Number: SB 2X-95-13

Issued: November 30, 2010

SNS SUBJECT: 95-00 SPECIAL EQUIPMENT - CAPS Strap Inspection And Grommet Installation

Figure 01
Pass-Through Slot Enlargement and Grommet Installation

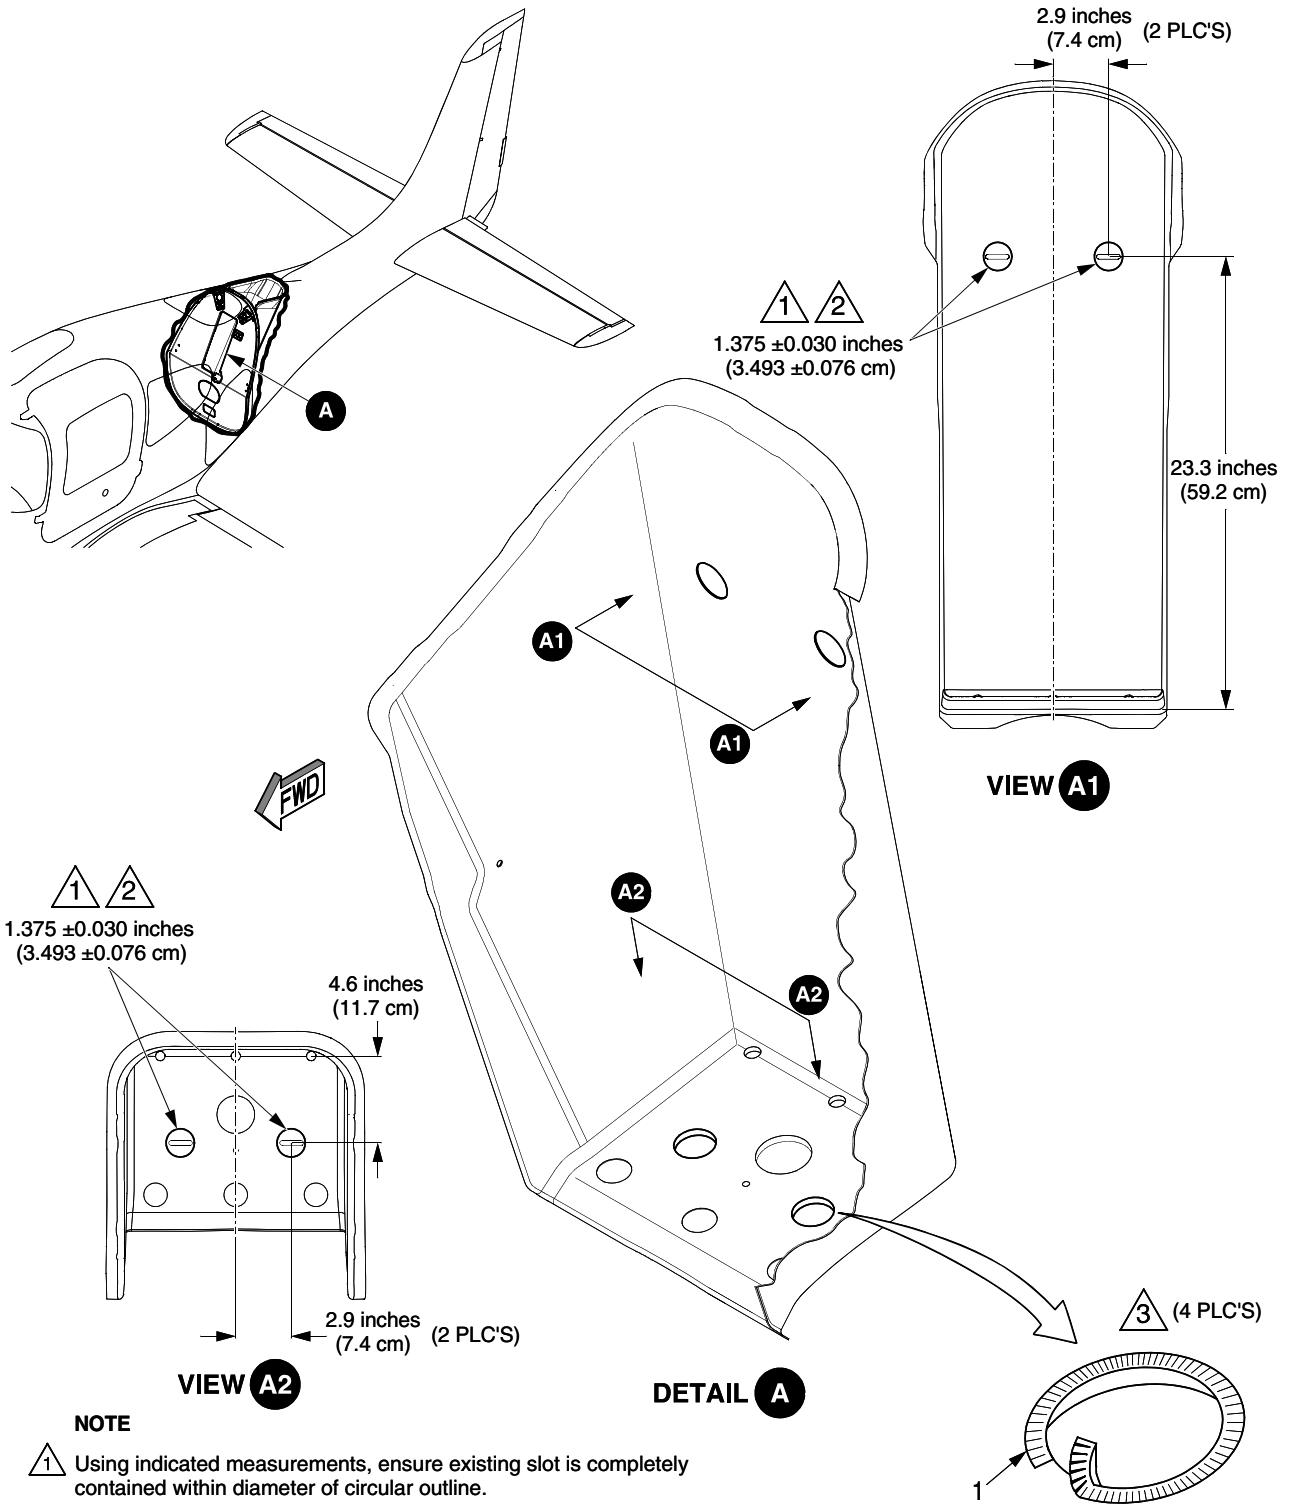
G. Modify upper CAPS compartment pass-through slots. **(See Figure 01)**

- (1) Locate aft upper pass-through slots in the CAPS compartment.
- (2) Measure 23.3 inches (59.2 cm) up from bottom of CAPS compartment and mark horizontal line.
- (3) Measure 2.9 inches (7.4 cm) left from center line of CAPS compartment and mark vertical line.
- (4) Measure 2.9 inches (7.4 cm) right from center line of CAPS compartment and mark vertical line.
- (5) Intersect vertical lines with horizontal line for location of cut-out holes.
- (6) Mark 1.375 ±0.030 inch (3.493 ±0.076 cm) circular outline at measured intersections.

Note: Ensure existing slot is completely contained within diameter of circular outline.

- (7) Position vacuum cleaner nozzle near work area to reduce dust/debris migration.
- (8) Using rotary tool with carbide cutting wheel, carefully grind circular outlines from CAPS compartment.
- (9) Deburr all edges of cut-out holes.
- (10) Solvent clean cut-out holes with isopropyl alcohol. (Refer to AMM 20-30)
- (11) Using epoxy adhesive, secure thin grommets to upper cut-out holes per adhesive manufacturer's application instructions.

H. Modify lower CAPS compartment pass-through slots. **(See Figure 01)**

- (1) Locate aft lower pass-through slots in the CAPS compartment.
- (2) Measure 4.6 inches (11.7 cm) forward from center of aft tooling holes and mark horizontal line.
- (3) Measure 2.9 inches (7.4 cm) left from center line of CAPS compartment and mark vertical line.
- (4) Measure 2.9 inches (7.4 cm) right from center line of CAPS compartment and mark vertical line.
- (5) Intersect vertical lines with horizontal line for location of cut-out holes.
- (6) Mark 1.375 ± 0.030 inch (3.493 ± 0.076 cm) circular outline at measured intersections.

Note: Ensure existing slot is completely contained within diameter of circular outline.

- (7) Position vacuum cleaner nozzle near work area to reduce dust/debris migration.
- (8) Using rotary tool with carbide cutting wheel, carefully grind circular outlines from CAPS compartment.
- (9) Deburr all edges of cut-out holes.
- (10) Solvent clean cut-out holes with isopropyl alcohol. (Refer to AMM 20-30)
- (11) Using epoxy adhesive, secure thick grommets to lower cut-out holes per adhesive manufacturer's application instructions.

- NOTE**
- 1 Using indicated measurements, ensure existing slot is completely contained within diameter of circular outline.
 - 2 Using rotary tool with carbide cutting wheel, carefully grind circular outlines from CAPS compartment.
 - 3 Bond grommets with 5 minute epoxy into each cut-out hole.
